APPLICATION NO.	FILING DATE	FIRST NAMED INVENTOR	ATTORNEY DOCKET NO.	CONFIRMATION NO.
10/663,918	09/16/2003	Richard A. Wilsak	37,512	2288
BP America Ir	7590 05/07/200	EXAMINER		
Docket Clerk, BP Legal, M.C. 5East			POPOVICS, ROBERT J	
4101 Winfield Warrenville, II		ART UNIT	PAPER NUMBER	
,			1797	
			MAIL DATE	DELIVERY MODE
			05/07/2009	PAPER

DETAILED ACTION

Figure 1 Annotated in View of The Example

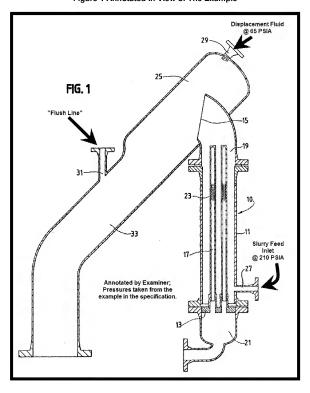
In this regard, it is noted that the only apparatus disclosed to accomplish this step is Fig. 1, which discloses an open chute 33. As such, it is unclear how the above stated step would be accomplished. It is axiomatic that a fluid under pressure will follow the path of least resistance. Referring to Fig. 1, that would be chute 33.

Unfortunately, this argument is not commensurate with the scope of the claims, which where previously amended to specify that all steps took place simultaneously. When the process steps all take place simultaneously, there are no "initial" steps. Applicants later refer to the sole example in the case, when challenging the rejections made. After considering the pressures set forth in the sole example, it is unclear how any displacement fluid at 65 PSIA will simultaneously flow down filter column 10, when slurry at 210 PSIA is being introduced thereto via slurry feed inlet 27. Applicants trivialize the controls/valves necessary to practice the invention, citing to <u>Hybritech</u>. Unfortunately, the undersigned disagrees, considering those controls essential to the practice of the invention. Applicants' arguments, citing to the sole example, only serve to bring more questions to the surface. What would permit flow in a direction from a lower pressure (e.g., 65 PSIA) to a region of higher pressure (e.g., 210 PSIA)?

Comparing Figure 3 of US 2007/0225539 A1 with Fig. 1 of the instant disclosure

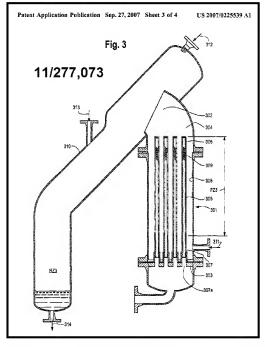
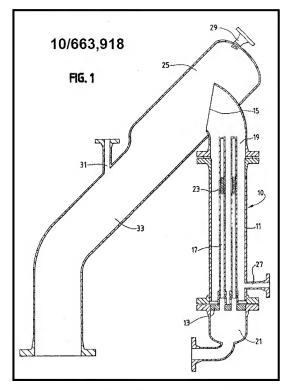
Claims 1,2,5-16,40,41,44,45,48 and 49 are rejected under 35 U.S.C. 112, first paragraph, because the **best mode** contemplated by the inventor has not been disclosed. Evidence of concealment of the best mode is based upon **Figure 3** of **US** 2007/0225539 A1.

it would appear that something is missing. Specifically, there is no means disclosed for controlling the pressure at the open end of chute 33.

If, as Applicants have argued, "those skilled in the art, such as chemical engineers, would readily recognize both the need for and identity of appropriate pressure controls, such as valves and the like" and, that a "patent need not teach, and preferably omits, what is well known in the art," why then, have Applicants included a disclosure of such means in 11/277,073? It is submitted that Applicants recognized the deficiency of this disclosure, and attempted to remedy it in 11/277,073.
